Tuesday, April 19, 2016 Breckenridge Council Chambers 150 Ski Hill Road

PLANNING COMMISSION MEETING

Planning Commission Staff Report

Planning Commission Staff Report

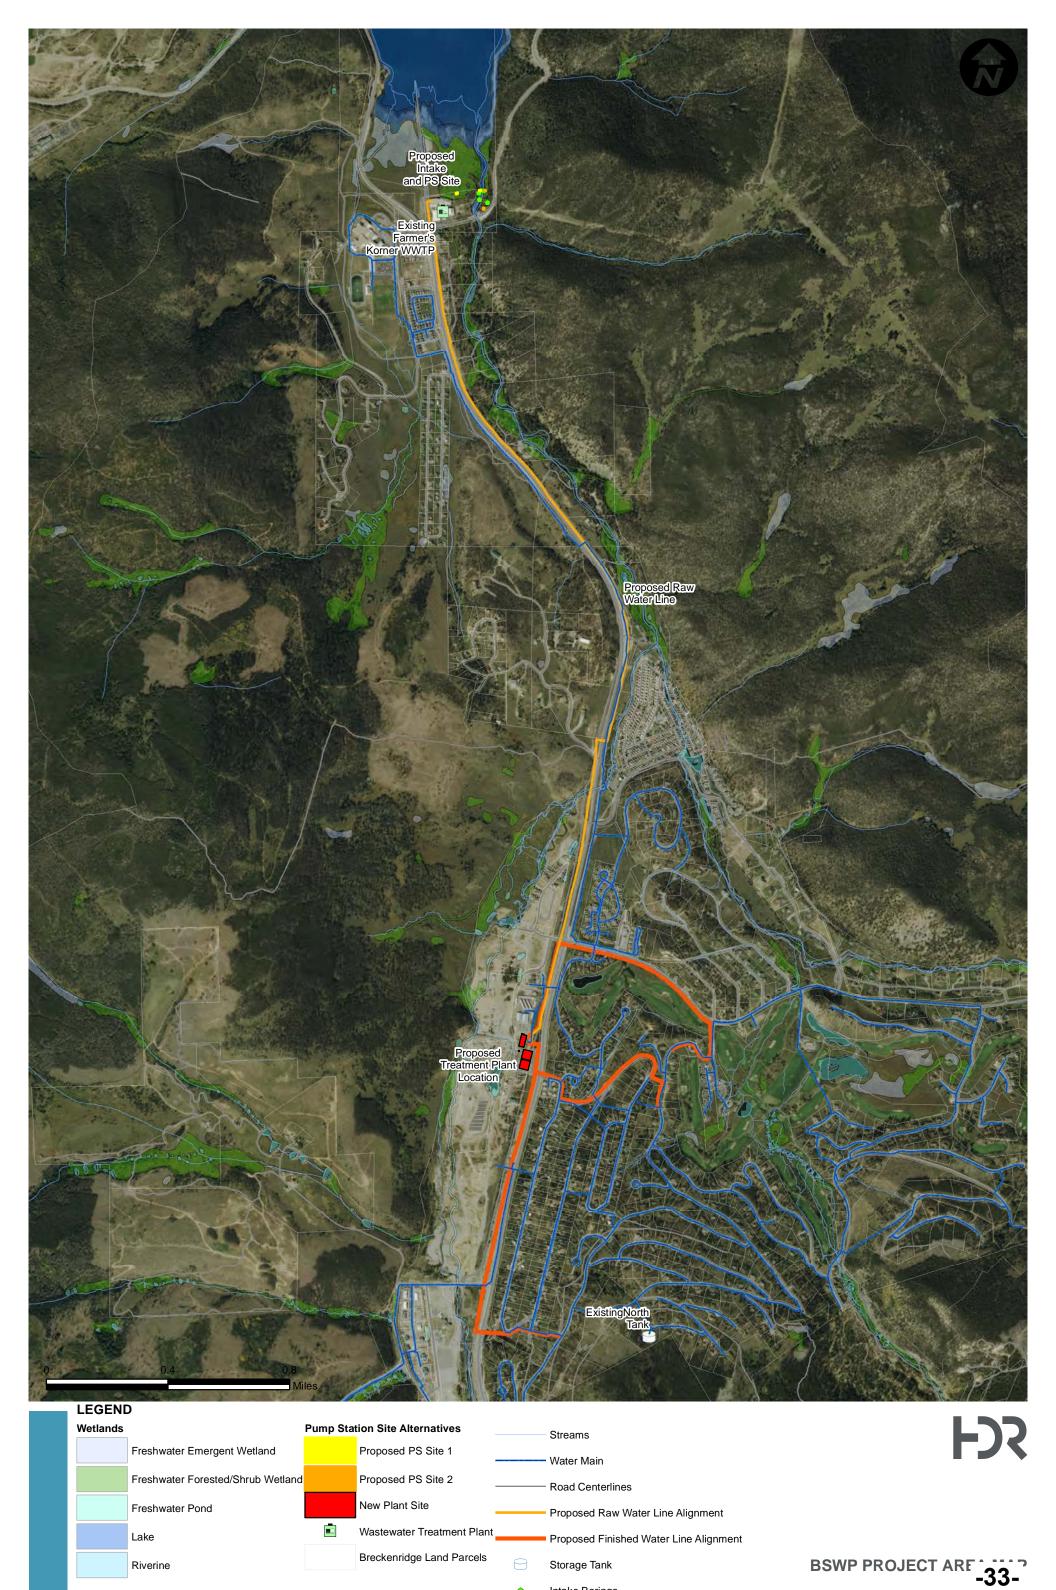
Landscaping along the eastern property boundary adjacent to the Highway 9 right of way should be enhanced as reasonably possible to assist in providing an effective buffer from Highway 9 to the site. Landscaping is also encouraged.

The plans are showing preservation of all the existing landscaping features along the Highway. This plan preserves the buffering with large existing trees and existing berming. At this early review, there is no proposed landscaping shown. We will have more information at the town project hearing.

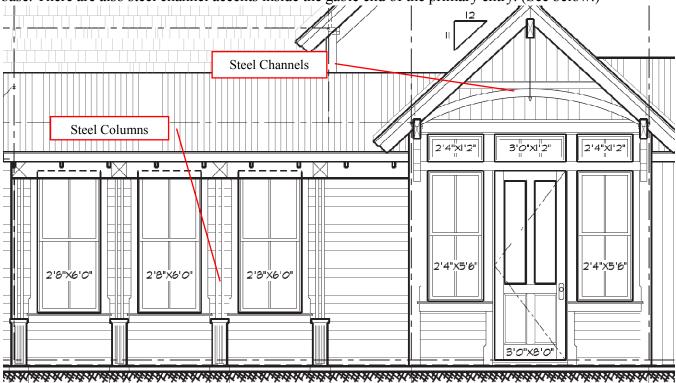
Priority Policy 164 states: New buildings should have primary facades similar in dimension to those found historically. Typical building widths of surviving historic buildings range between 16 and 44 feet; the average is 31 feet. The Design Standard states: Reinforce typical narrow front façade widths that are typical of historic buildings in the area.

- Projects that incorporate no more than 50 feet of lot frontage are preferred.
- The front façade of a building may not exceed 30 feet in width.

The front façade is 22-feet wide. The secondary façade is 16-feet wide. We have no concerns.

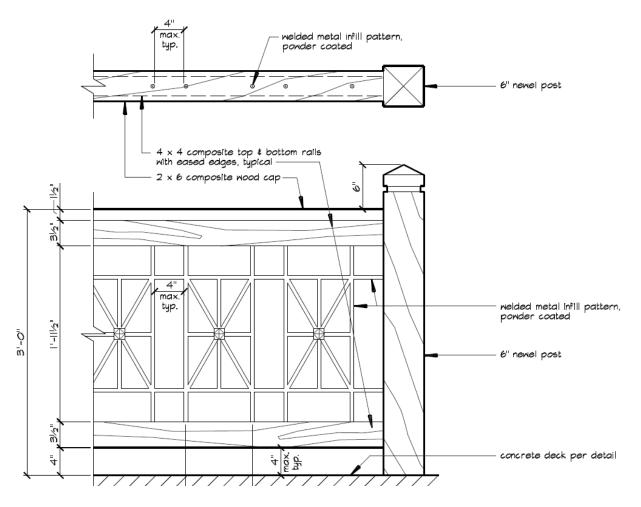
The **South Elevation** is similar to the North Elevation with the exception of an added bay window in the restaurant dining area in the front module. This window has inset painted wood panels at the base instead of the clapboard siding. The double hung windows are vertically oriented and spaced with a similar solid-to-void ratio of other historic buildings in the area. The connector has three small windows set above the wainscot and a 3/4 light door. The siding on the rear module has more rustic finishes with 1X random width rough sawn oiled finish with a small portion of a dull copper wall pane panel (less than 25% of the elevation).

The roof forms are simple gables with the asphaltic shingles with lower shed roofs sheathed in rusted corrugated metal. We have no concerns.
